Capital School District
Central Middle School
Interior Renovations
211 Delaware Ave. Dover Delaware 19901
Bid Pac E— Contracts 1 thru 10
October 7, 2024

Addendum No. 1

PROJECT: Central Middle to Elementary School Interior Renovation

PROJECT NO: 2021101.00

E-501

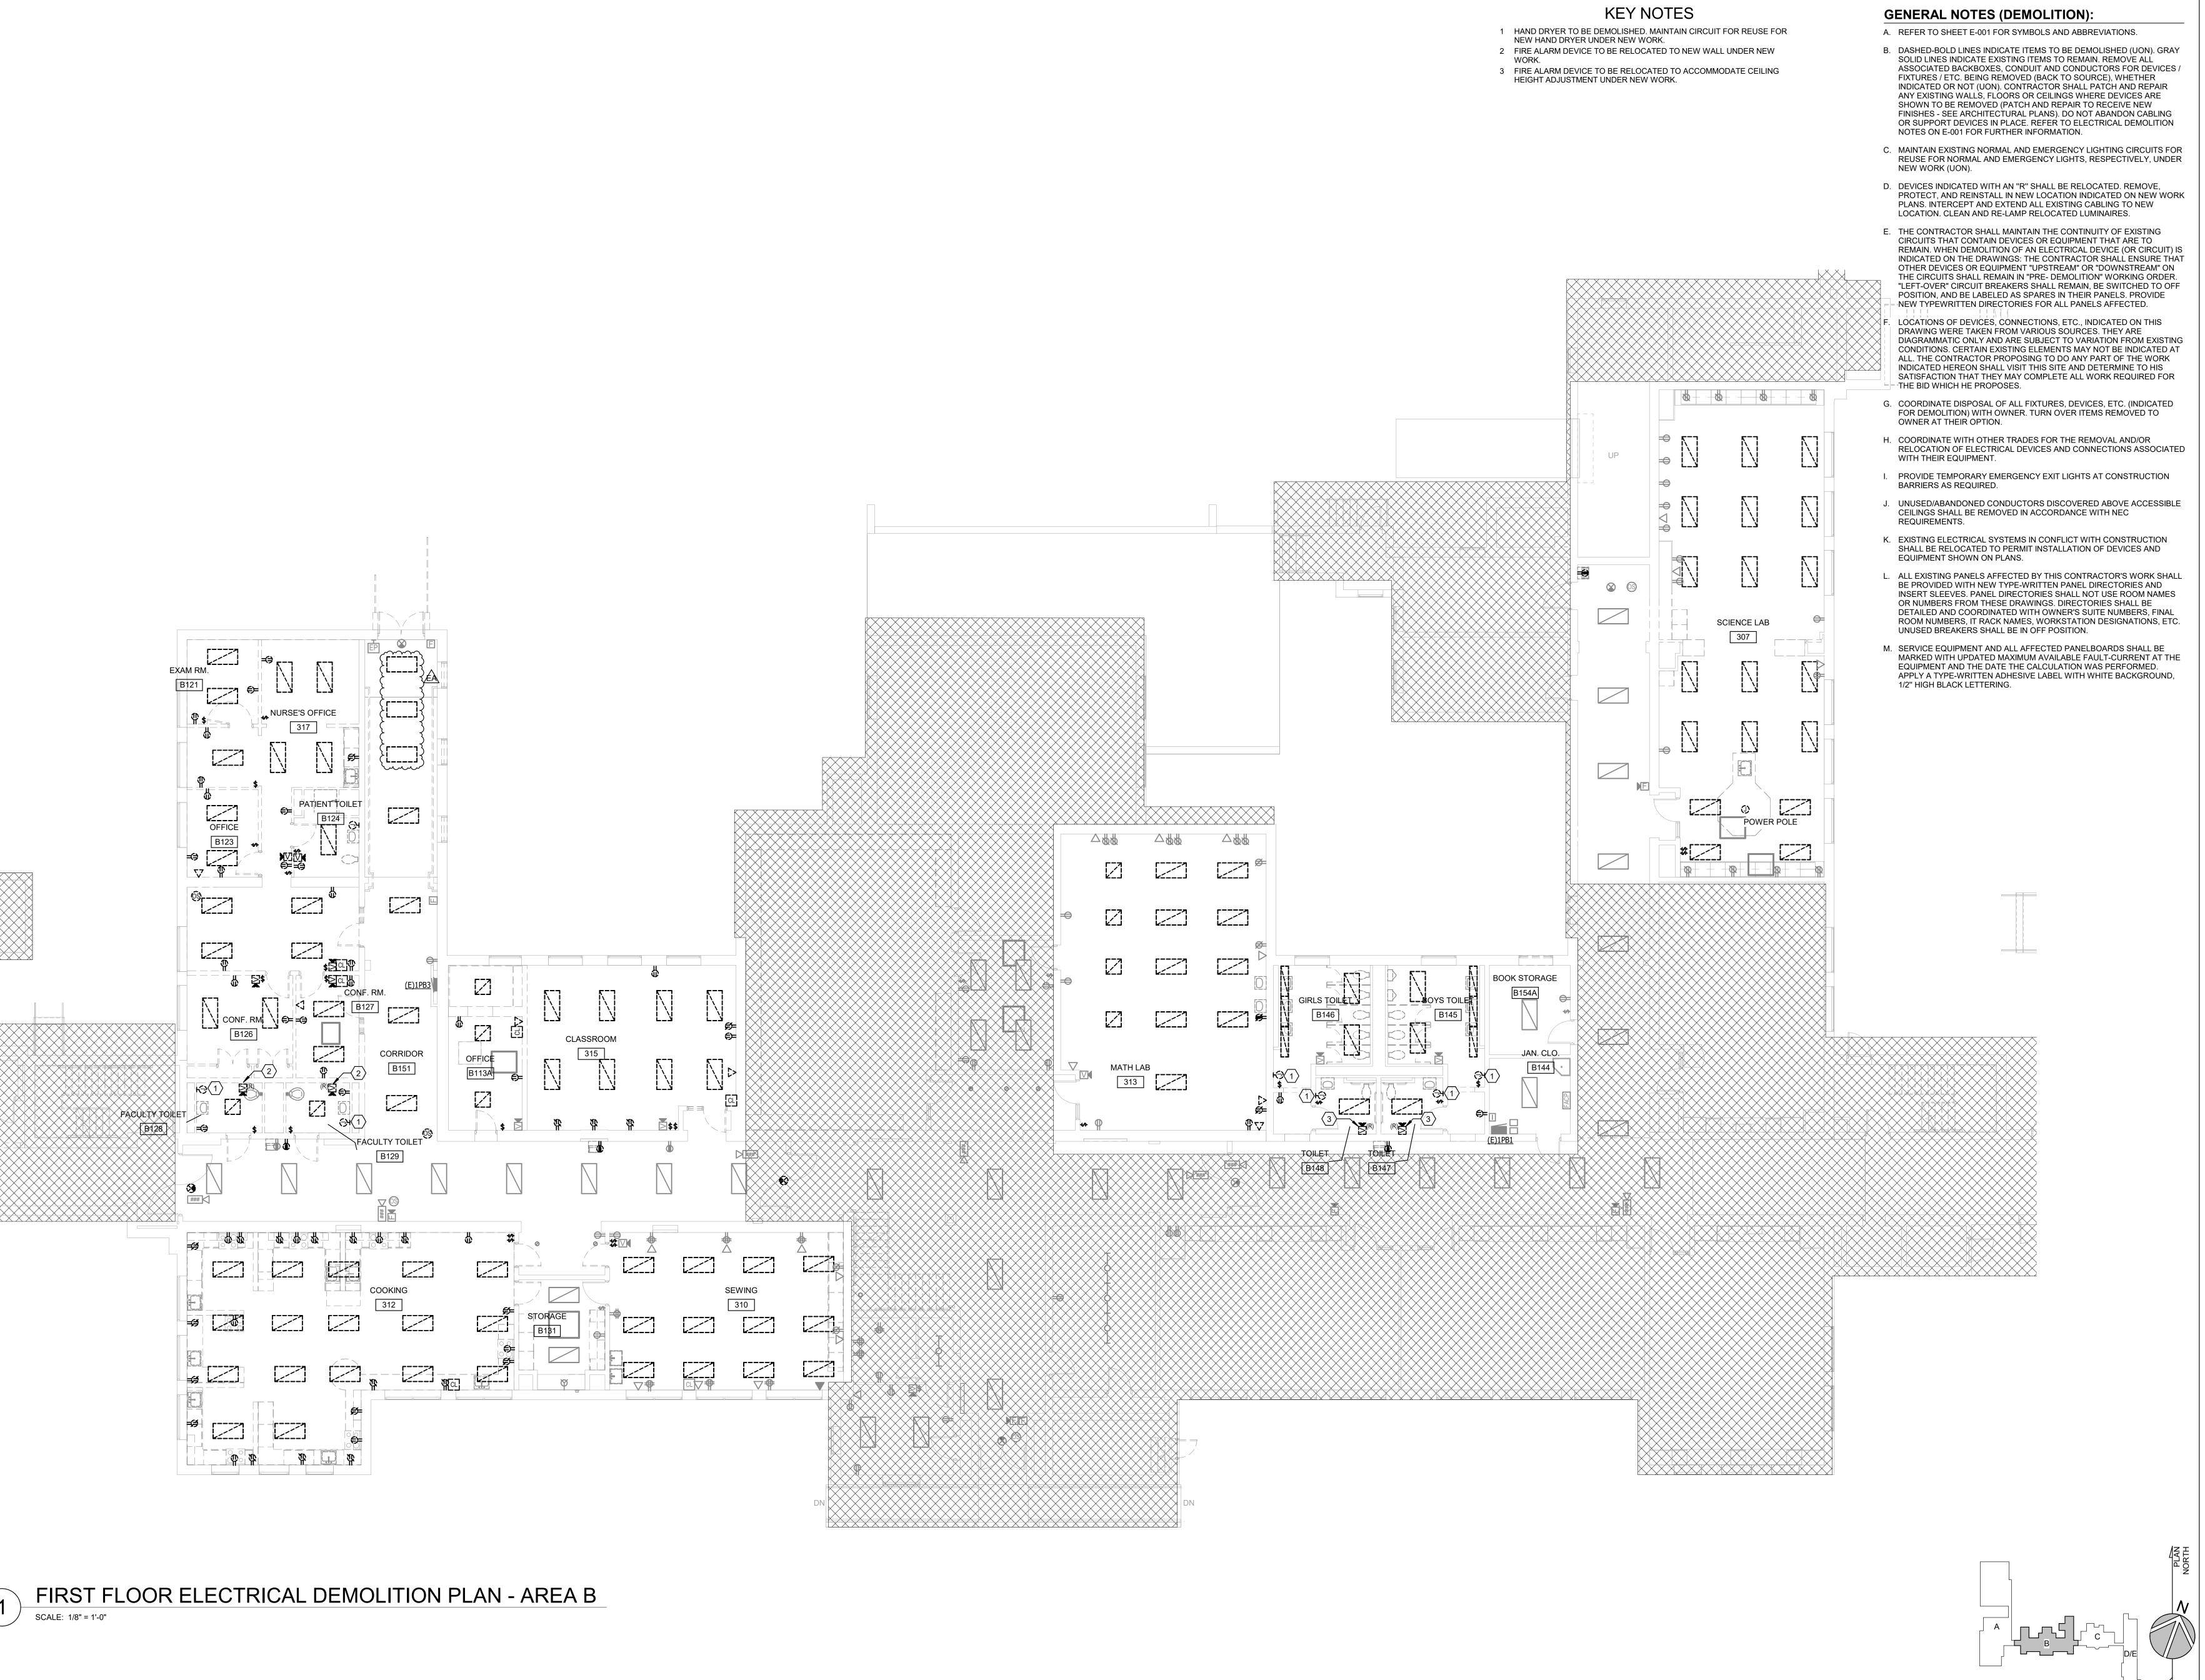
a. ADD lighting fixtures A6 and A6(EM) to lighting fixture schedule.
